Service Bulletin

Subject: Steering Shudder (Vibration) During Slow Speed Maneuvers

Models: 2010-2017 Chevrolet Equinox
2010-2017 GMC Terrain
Equipped with Engine RPO LF1, LFW or LFX

This PI has been revised to add the 2016 and 2017 Model Years. Please discard PI0814D.

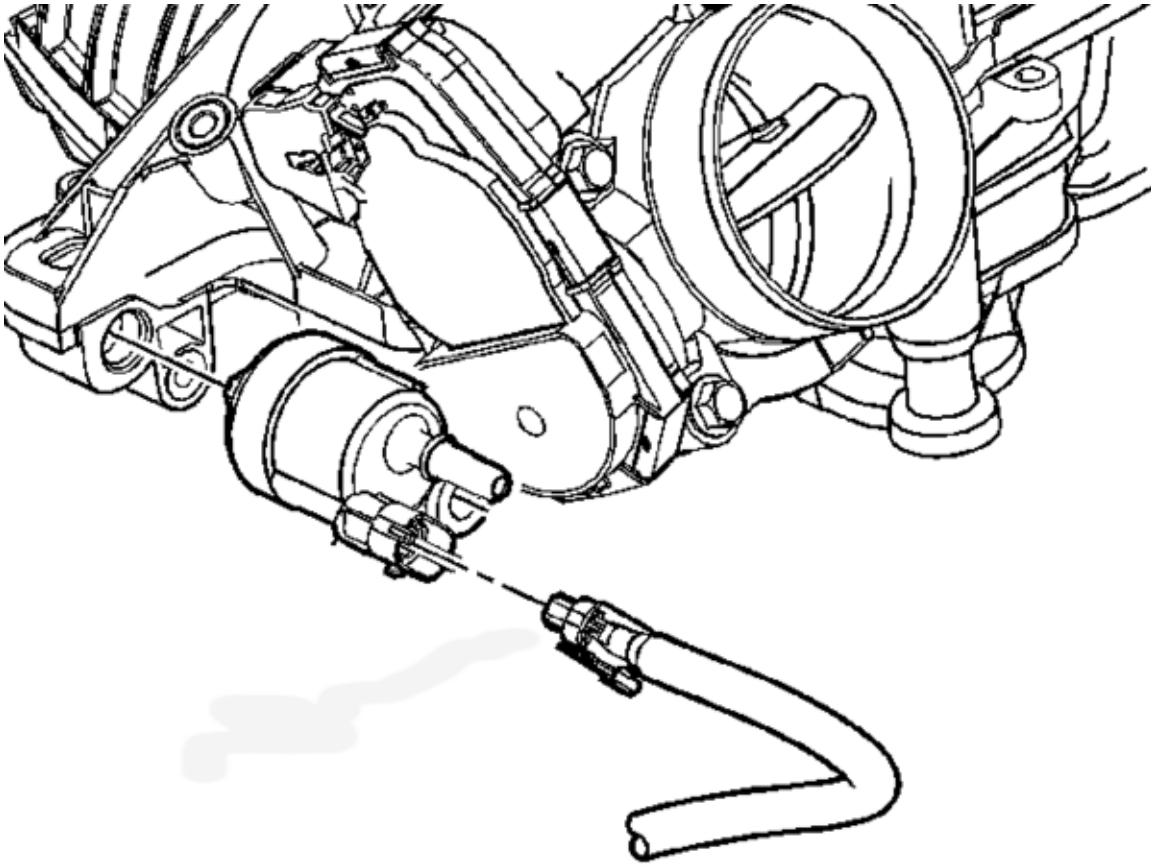
This condition can be corrected by replacing the following components: power steering gear inlet hose assembly, generator (alternator) assembly and the emission evaporative hose. The revised power steering hose assembly is longer and provides a dampening quality. The revised generator has an isolation pulley and the revised evaporative hose is designed to clear the revised power steering hose.

Important: When the revised components (hoses) are installed, they must not have contact with the underbody or components. Use care to position the hoses to prevent any contact with other components.

1. Install the revised generator. Refer to *Generator Replacement* in SI.
2. Install the revised power steering inlet hose. Refer to *Power Steering Gear Inlet Pipe/Hose Replacement* in SI. Leave the intake manifold cover off.
3. Install the revised evaporative emission canister purge hose assembly as follows:

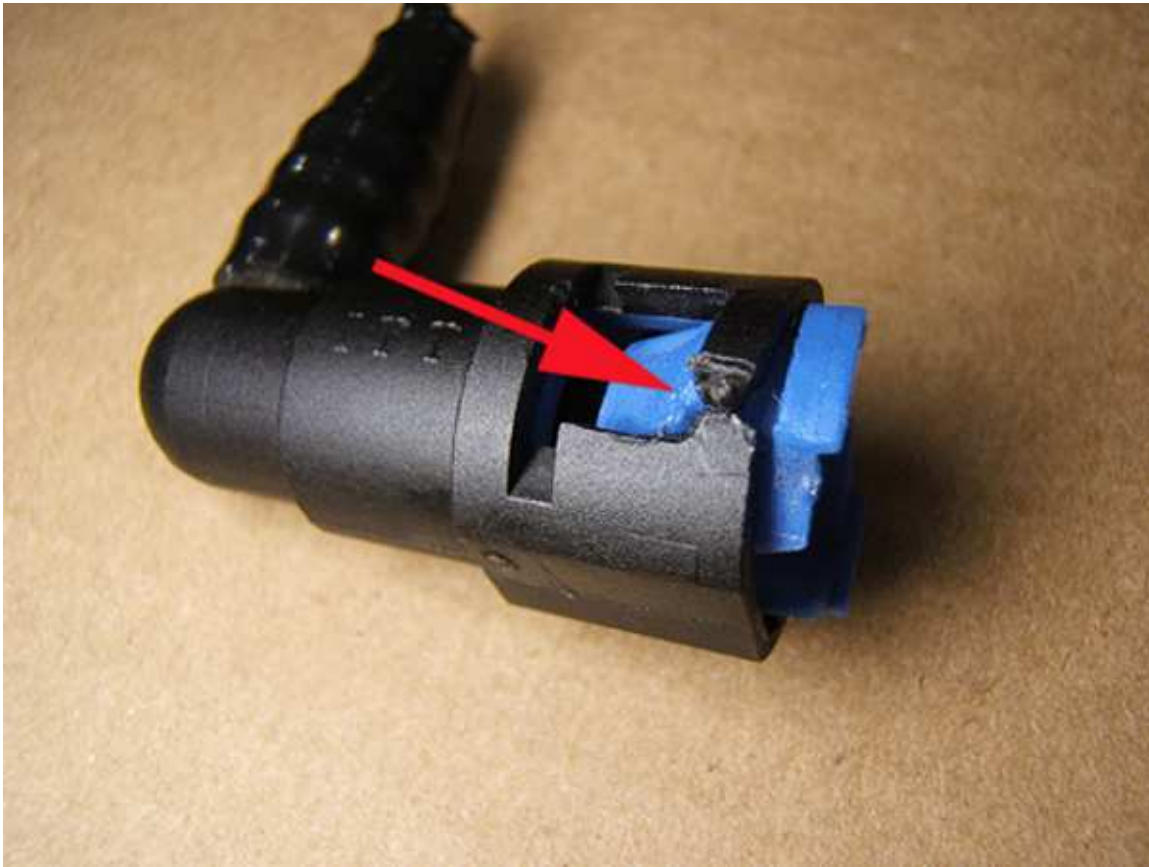
3.1. Disconnect the hose from the evaporative emission canister purge solenoid valve located by the base of the throttle body.

3.2. Disconnect the hose from the chassis to canister evaporative emission line.

It may be necessary to cut the plastic connector on the hose if the blue plastic retention collar cannot be released. A new connector is part of the new hose assembly.

3.3. Remove the existing hose and install the new hose assembly.

Route the new hose in a way that avoids contact with chassis and body components. Connect both ends of the hose.

4. Install the clip as shown, connecting the new evaporative emission canister purge hose assembly to the black metal cross car brake pipe.
5. Inspect the new evaporative emission canister purge hose assembly and the revised power steering inlet hose to ensure no components are coming into contact with the new hose assemblies. If contact is present, loosen and reposition the new hose.
6. Fill and bleed the power steering system. Verify the fluid level. Repeat the bleed procedure, if necessary. Refer to *Power Steering System Bleeding* in SI.
7. Reinstall the intake manifold cover.
